Memphis-Shelby County Airport Authority ("Authority")

Addendum No. 1
To
Request for Proposals 24-1477-00
For
Parking Guidance System

Issue Date: February 25, 2025

QUESTIONS AND ANSWERS REGARDING MSCAA PROJECT 24-1477-00 Parking Guidance System February 25, 2025

SHORT/LONG TERM GARAGE

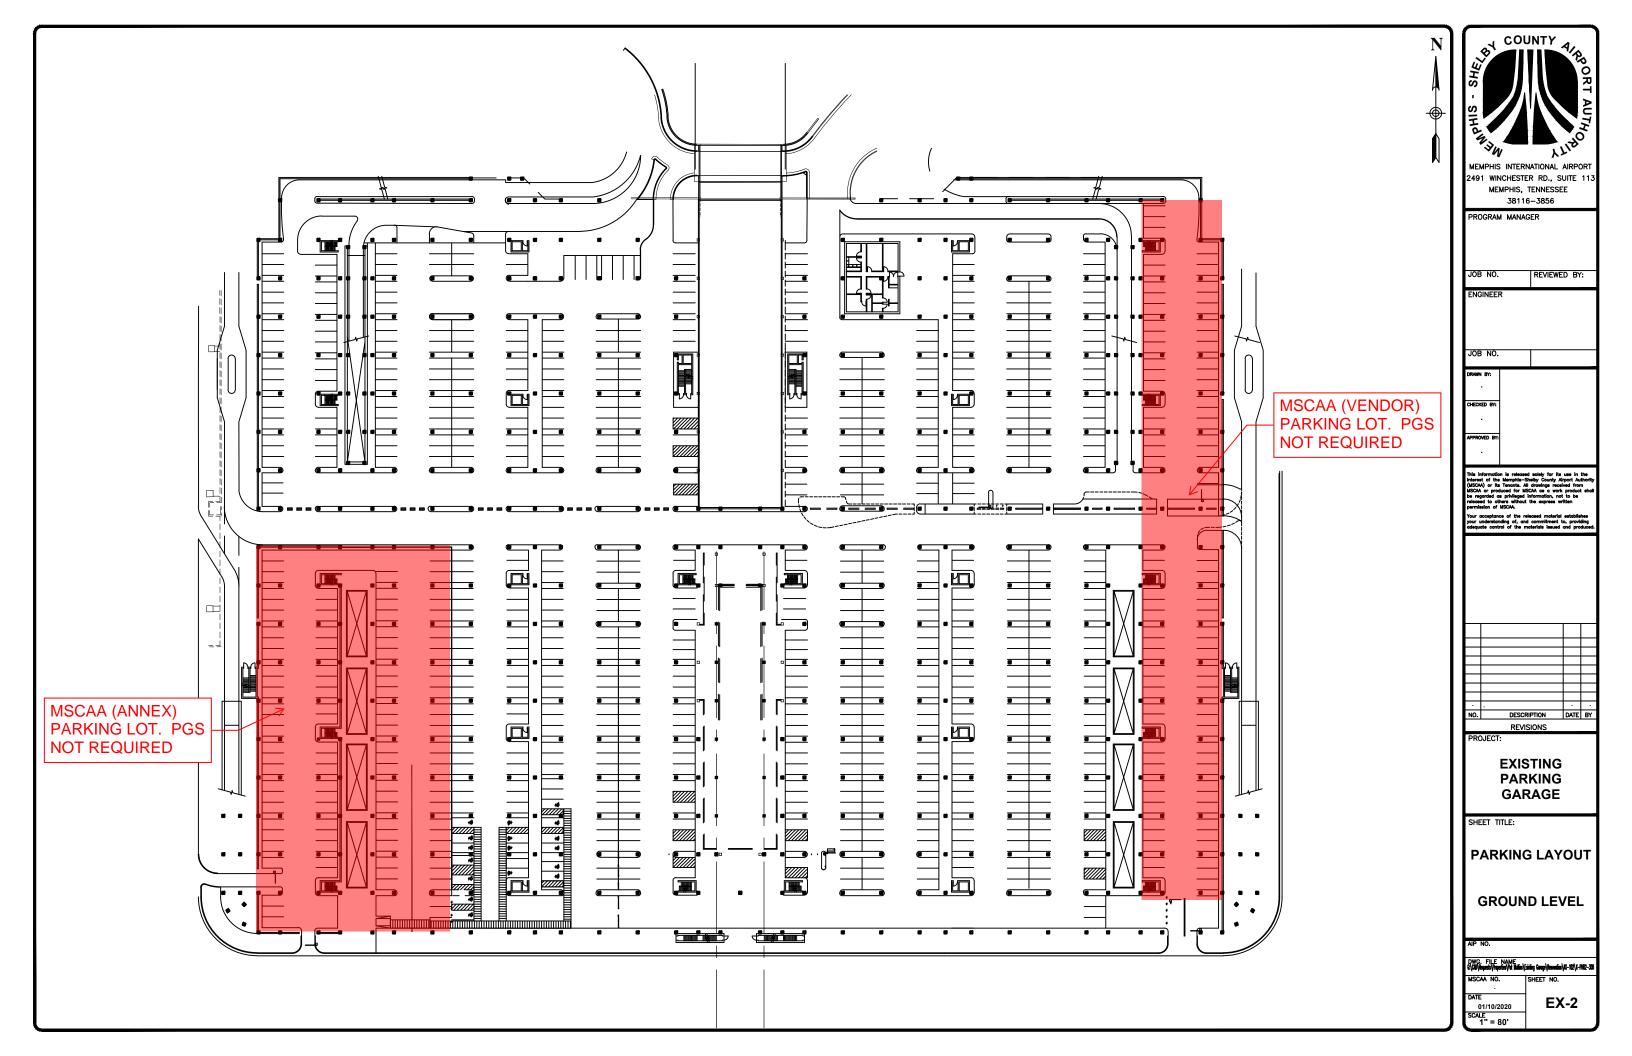
22.	Is there a fiber connection between the Economy garage and Short/Long term garage? If so, please provide locations and description.
	There is available MSCAA fiber between the Economy Garage and Short/Long Term Garage. If a fiber connection between garages is needed, please note it in your proposal.

ROOF LIGHTING PLANS &
LIGHT POLE SUBMITTALS

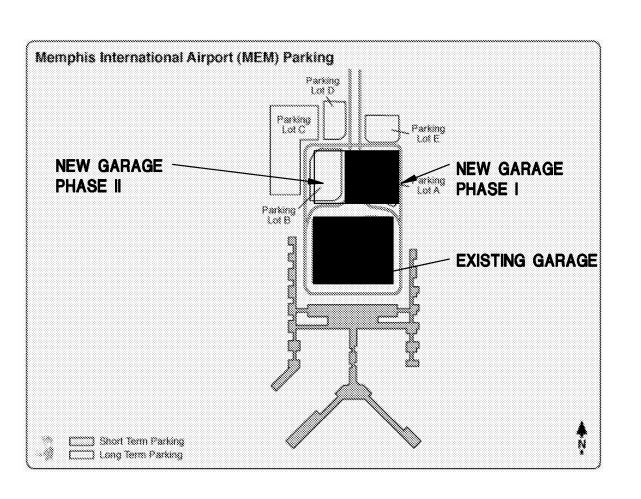
27.	The RFP document includes the following requirement: The Economy Garage existing lighting poles are not permitted for use, as they are equipped with a mechanical device that enables the lights to move up and down. The poles have the mechanical device only at one side of the pole. Could the opposite side of the pole used for the camera installation? If yes, can a layout be provided of approved camera pole locations?
	Please provide specifications for new camera poles. Will new camera pole locations require a concrete pole base? If concrete bases are required, what are the pole base specifications?
	Yes. The existing Economy Garage light poles can be used as long as the mounting does not impact the mechanical lift on the pole. See light pole drawings included in this Addendum 1.
	There are no specifications for new camera poles. Should be similar match in material and color of the existing poles. Height TBD by Vendor but not to exceed existing light poles. Any new camera poles will need to be designed by the awarded Respondent and approved by MSCAA prior to installation.

38.	Is it a requirement to provide single-space detection for the garage rooftop. Will the Airport allow for ground-mounted wireless vehicle sensors in lieu of aerial cameras for the roof levels? (a) Please provide specifications of the existing poles for both the Long-Term/Short-Term Garage and Economy Garage. (b) If additional poles are needed to provide full coverage, are there additional civil requirements the vendor is responsible for? (c) Is there a maximum height limit for poles added to the Economy Garage?					
	 See Answer to Question 33. (a) Existing pole height on Long/Short Term Garage is 65'. Existing pole height on Economy Garage is 28'. MSCAA does not have additional existing data on the Long/Short Term Garage. See additional supplemental drawings in this Addendum No. 1 for information on the Economy Garage poles. (b) Awarded vendor is responsible for designing additional poles and will be approved by MSCAA prior to installation. Should be similar match in material and color of the existing poles. Height TBD by Vendor but not to exceed existing light poles. (c) All new poles must stay below the height of the existing light poles.
